[SWAN] Assembly process improvement

Model Name: BFX-UA300

Document Version: ALT_STB_MP_CSMTINS_001

Issued Date: 2022.06.09

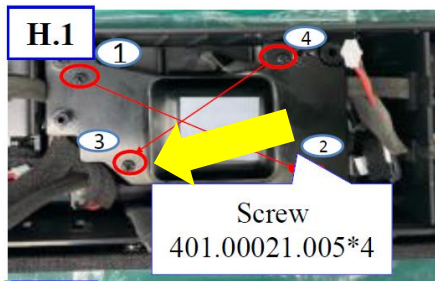
- Skip the screw 1 point due to FFC cable is pressed
 - Please review and feedback to us.
